SUBJECT: ISSUANCE OF AMENDMENT NO. 119 TO FACILITY OPERATING LICENSE NO. DPR-23 - H. B. ROBINSON STEAM ELECTRIC PLANT, UNIT NO. 2, REGARDING REMOVAL OF OPERATING RESTRICTIONS FOR SINGLE HIGH PRESSURE INJECTION PUMP OPERATION (TAC NO. 68072)

AMENDMENT NO. 119 TO FACILITY OPERATING LICENSE NO. DPR-23 - ROBINSON, UNIT 2

ATTACHMENT TO LICENSE AMENDMENT NO. 119

SAFETY EVALUATION BY THE OFFICE OF NUCLEAR REACTOR REGULATION  
RELATED TO AMENDMENT NO. 119 TO FACILITY OPERATING LICENSE NO. DPR-23  
CAROLINA POWER & LIGHT COMPANY  
H. B. ROBINSON STEAM ELECTRIC PLANT, UNIT NO. 2  
DOCKET NO. 50-261

FIGURE 3.10-3 NORMALIZED AXIAL DEPENDENCE FACTOR FOR  $F_q$  VERSUS ELEVATION  
(PEAK  $F_q = 2.32$ )

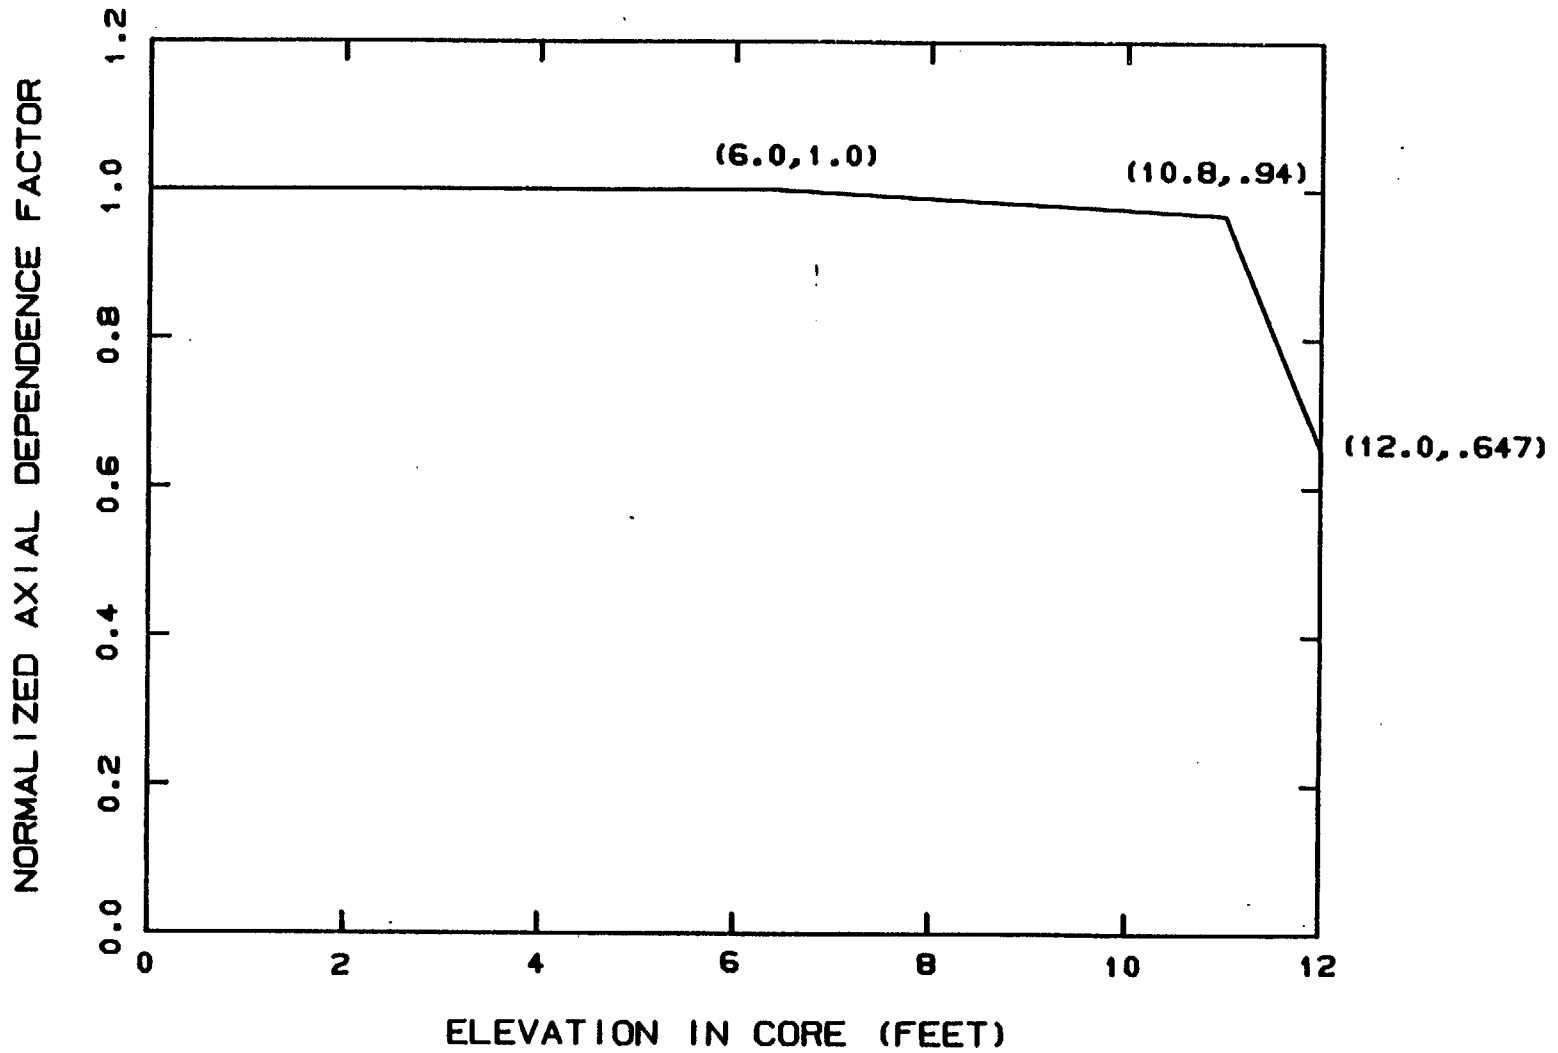
The amendment removes the restriction limiting operating power to 1380 Mwt with two operable safety injection pumps and increases the power peaking factor (Fq) to 2.32 from a value of 2.26. The amendment allows operation at a steady state reactor core power level not in excess of 2300 Mwt with two safety injection pumps operable.

$$F_Q(Z) \leq (2.32/P) \times K(Z) \text{ for } P > 0.5$$

where P is the fraction of rated power (2300 Mwt) at which the core is operating.  $F_Q(Z)$  is the measured  $F_Q(Z)$  including the measurement uncertainty factor  $F_U^N = 1.05$  and the engineering factor  $F_Q^E = 1.03$ .  $F_{\Delta H}$  is the measured  $F_{\Delta H}$  including a 1.04 measurement uncertainty factor.  $K(Z)$  is based on the function given in Figure 3.10-3, and Z is the axial location of  $F_Q$ .
